STAFF REPORT
COMMUNITY DEVELOPMENT DEPARTMENT

SUBJECT: H-2020-0089
Baraya Subdivision No. 6

Final Plat consisting of 39 building lots and 2 common lots on 4.5 acres of land in the R-15 zoning district for the sixth phase of Baraya Subdivision.

BARAYA SUBDIVISION NO. 6

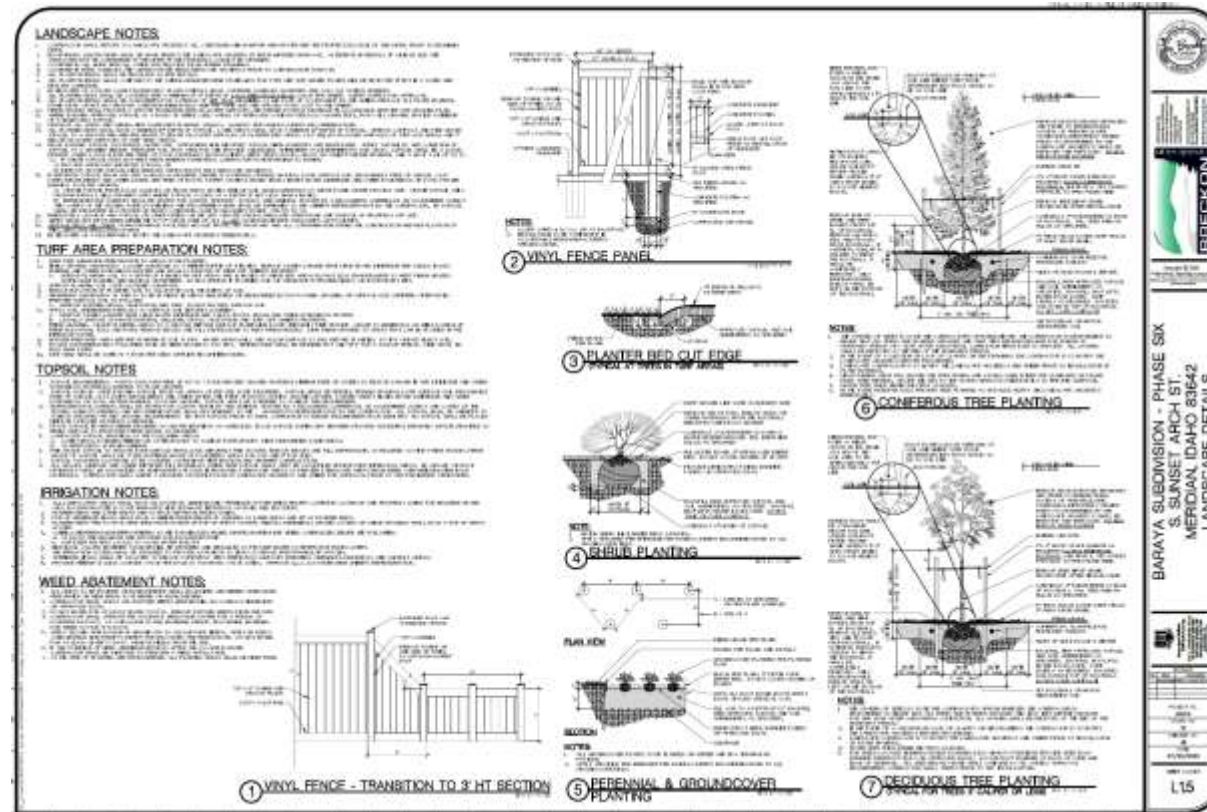
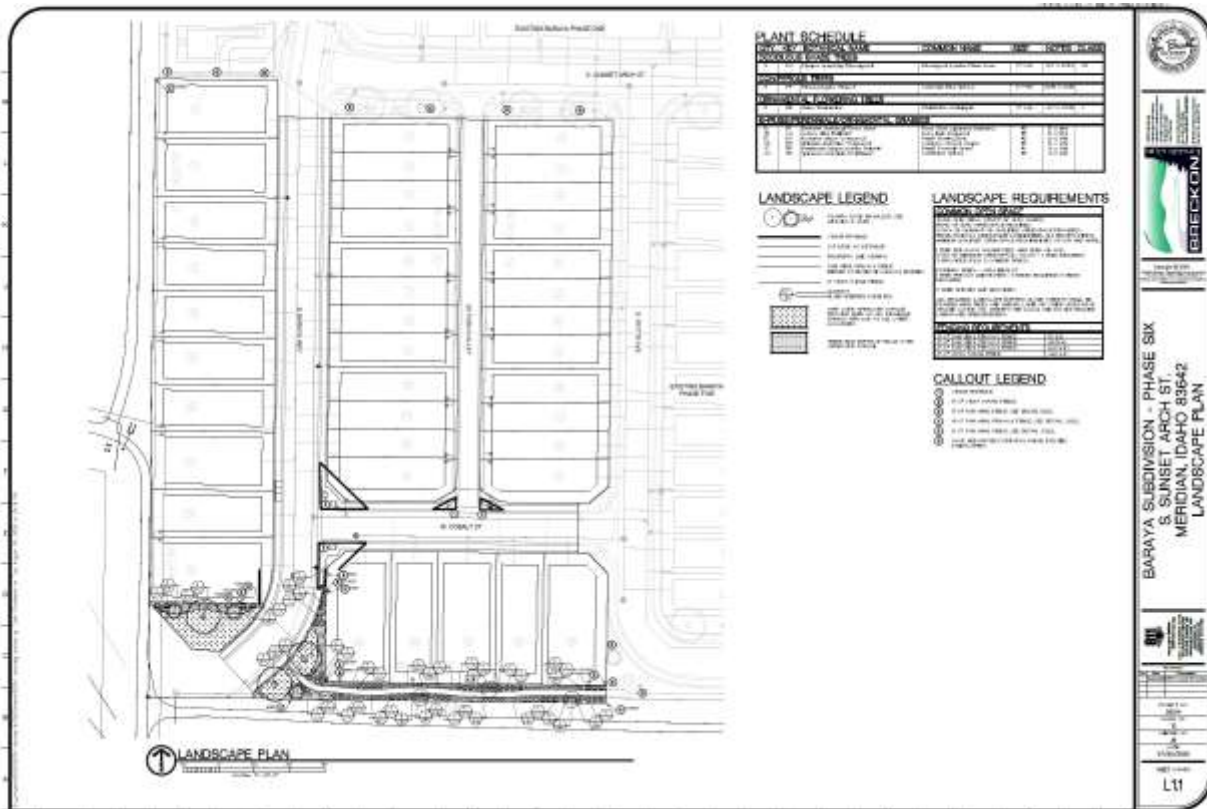
3. Prior to submittal for the City Engineer's signature, have the Certificate of Owners and the accompanying acknowledgement signed and notarized.
4. The final plat prepared by Bailey Engineering, Inc. stamped on 8/10/2020 by Gregory G. Carter, shall be revised as follows:

- a. Note #8: Include the recorded instrument number for the NMID pump station operation and maintenance agreement.
 - b. Note #9: Include the recorded instrument number or the ACHD License Agreement.

- c. Note #10: Include the recorded instrument number for the ACHD Permanent Easement.
 - d. Note #11: Include the recorded instrument number for the NMID license agreement.

- e. Note #13: Include the recorded instrument number for the NMID Marvin Lateral easement.
5. The landscape plan prepared by Breckon Land Design, dated 7/20/20, shall be revised as follows:
